(Revised issue 1)  
**Service Bulletin**

Ref. No. **2NJ-0016 (P022)**

<b>Subject:</b>	<b>Corrective measure for toner dropping (Developer unit 2)</b>		
<b>Model:</b>	<b>TASKalfa 9003i, TASKalfa 8003i, TASKalfa 7003i, TASKalfa 9002i, TASKalfa 8002i, TASKalfa 7002i</b>		
<b>Classification:</b>	<b>Field measures timing:</b>	<input type="checkbox"/> At Set Up <input type="checkbox"/> Next Periodic Maintenance <input checked="" type="checkbox"/> Next Visit/Service Call <input type="checkbox"/> Information only	
	<b>Phenomenon:</b>	<input type="checkbox"/> SC/Error <input type="checkbox"/> Paper Feeding/Conveying <input type="checkbox"/> Other <input checked="" type="checkbox"/> Image <input type="checkbox"/> Machine operation	
	<b>Type of change:</b>	<input checked="" type="checkbox"/> Hardware <input checked="" type="checkbox"/> Firmware and Software <input type="checkbox"/> Information	
<b>Remarks:</b>	<b>Related SB:</b>	2NJ-0015(P008)	
	<b>Revised ver.:</b>	- This time the description with (--->) is revised from the previous information. <Number of changes: 3> - Correction of setting values (P2)

[Contents of change]

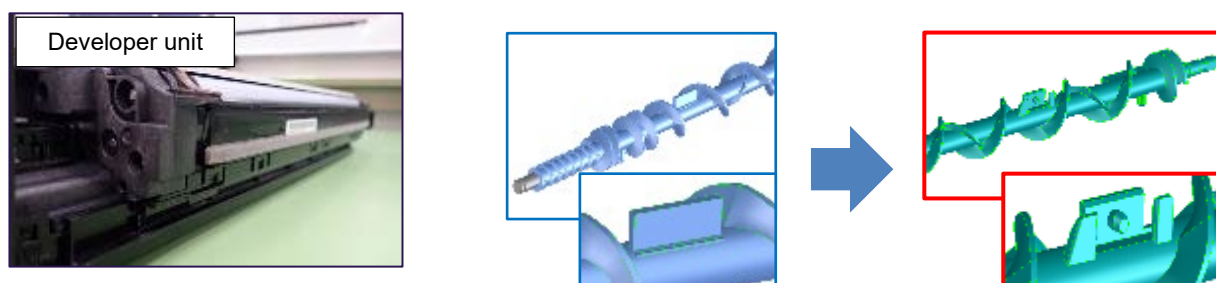
To address the accumulated toner on the developing sleeve roller, the developing rollers are rotated in reverse direction to collect the accumulated toner within the developer unit. With the reverse rotation of the developing rollers, the configuration of the scraper within the developer unit is changed to prevent the scraper from peeling off.

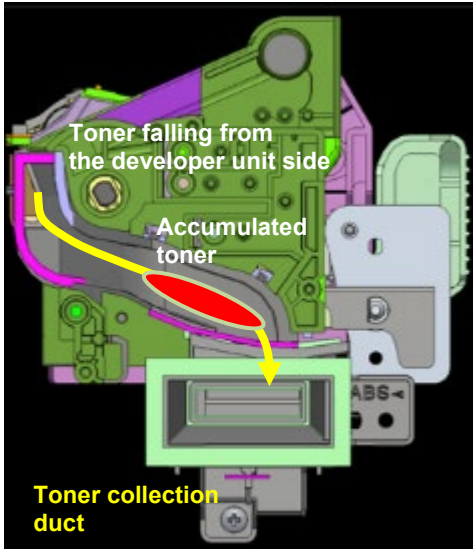
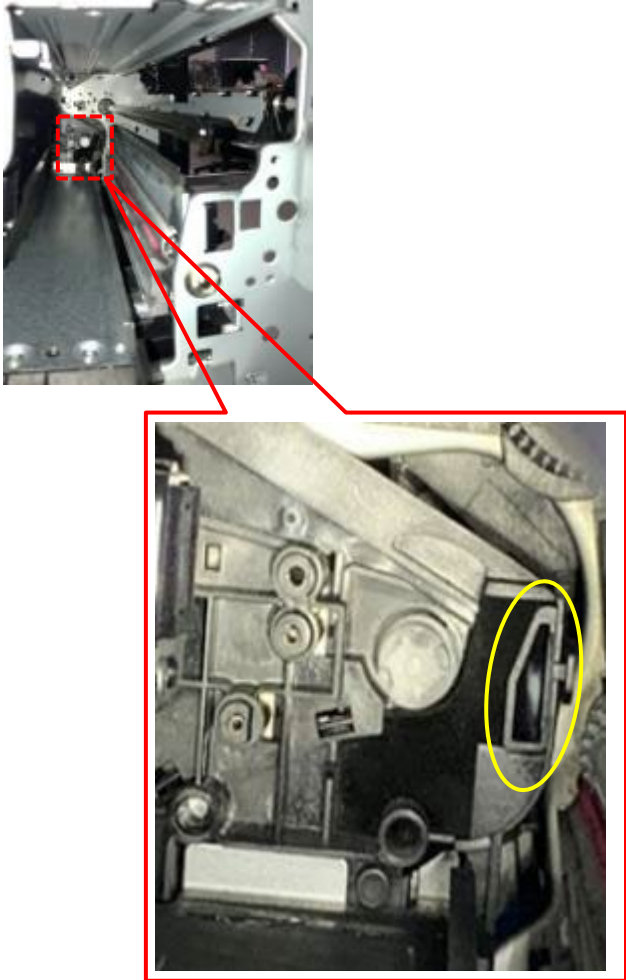
No.	Procedure	Details
4	Remove the rear lower cover and clean the inside of the toner collection duct (yellow circle).	
5	Remove the toner collection duct and clean duct inside the machine (yellow circle).	
6	Move the developing rail arm on the front side of the machine left and right 3 times to create vibrations.
